U.S. Department of the Interior BUREAU OF LAND MANAGEMENT

Notice of Intent

Sundry ID: 2698966 Type of Submission: Notice of Intent Date Sundry Submitted: 10/24/2022

Procedure Description: OXY USA Inc. respectfully requests approved to amend the subject wells AAPD deep intermediate cement job to align with the agreed upon R111-P updates presented at the latest JITC meeting. See the attached updated cementing program and diagram for reference.

Figure C] 4 – String – Un Cemented Annulus

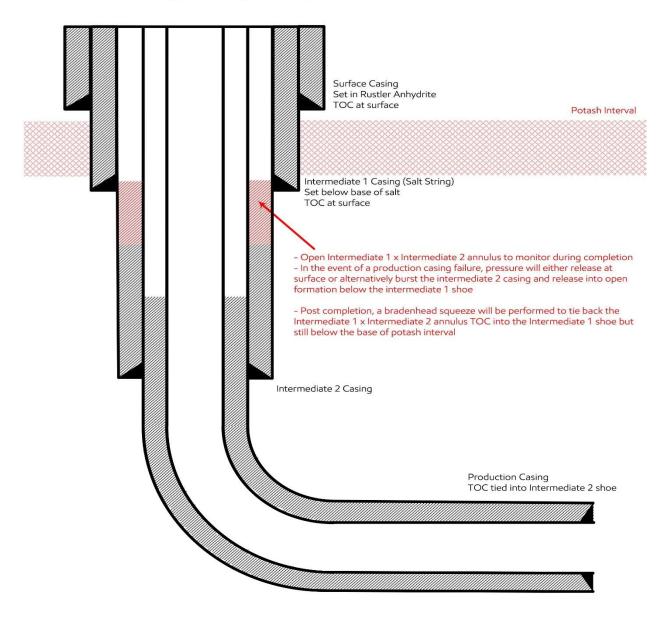
ALL PREVIOUS COAs STILL APPLY. CEMENT DESIGN UPDATE AS PER KPLA BEST PRACTICES (4-STRING INT1 X INT2 OPEN ANNULUS)

Oxy requests to update the Deep Intermediate Cement Job to align with the agreed upon R111-P updates presented from the JITC. (Below table based on Precious 30-18 Fed Com 175H)

Operator has proposed to pump down 7-5/8" X 9-5/8" annulus POST-FRAC. Operator must top out cement after the bradenhead squeeze and verify cement to surface. Operator can also check TOC with Echo-meter. CBL must be run from TD of the 7-5/8" casing to surface if confidence is lacking on the quality of the bradenhead squeeze cement job. Submit results to BLM.
